ON-SITE SEWAGE DISPOSAL SYSTEM HOWARD COUNTY HEALTH DEPARTMENT BUREAU OF ENVIRONMENTAL HEALTH

SUBDIVISION: Fox Den Farms LOT NUMBER: 5B

ADDRESS: 4001 Jumpers Hill Lane PROPERTY OWNER: James Gillicee

SEWAGE DISPOSAL SYSTEM

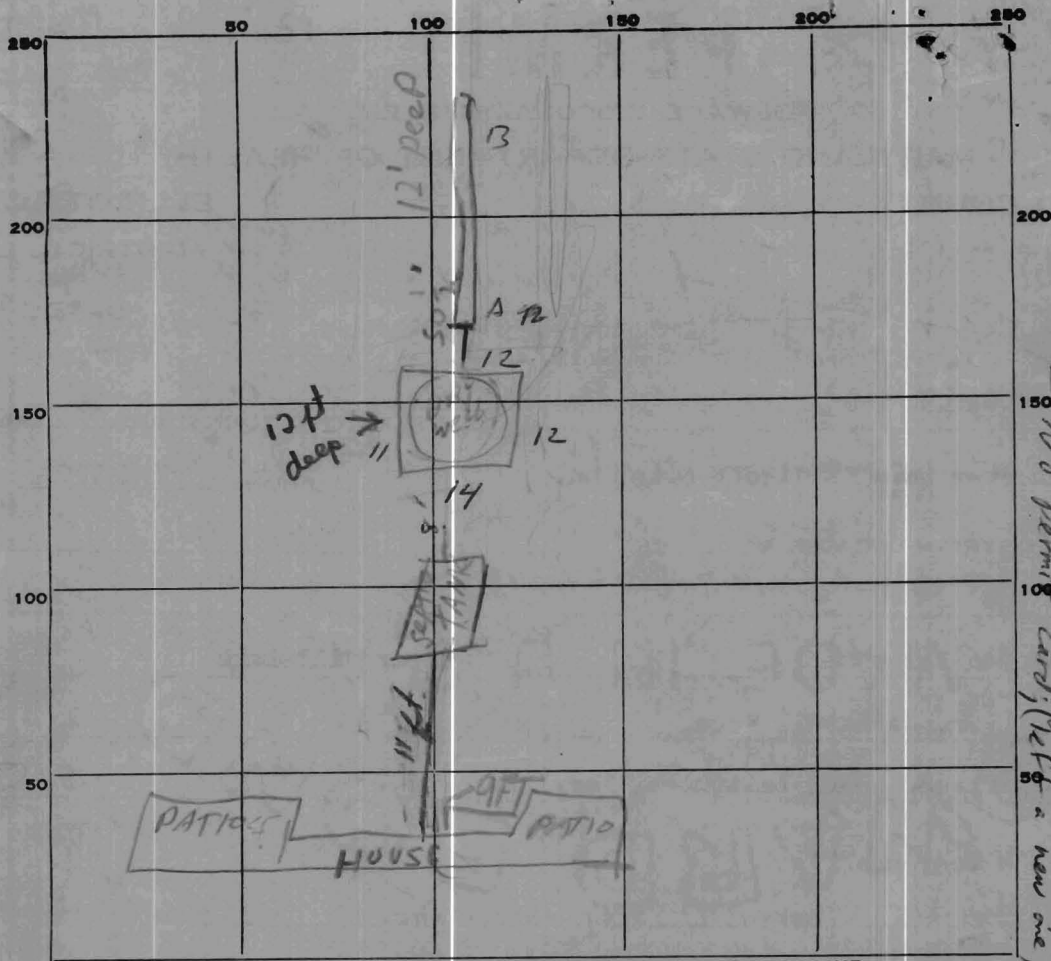
12/9/74 - Drywell - Cement cleanout 4 1/2 ft
 - Seal crack at open end on lid
 - Septic Tank - at open end (end away from house)
 - both inlet & outlet to be re-cemented - bottoms of "seals" are open
 - cover tank, call for signature of Dwyer ST.
 - No permit card; (let a new one)

Note: D.W. 1 1/2 ft below specs on max depth (also trench)

Nothing installed except 1250 gallon capacity septic tank. pipe from the frame to the septic tank is not connected. Give permission to complete system and put stone in trench.

DATE SYSTEM APPROVED 11/8/74 All violations corrected INSPECTOR H.J. 262
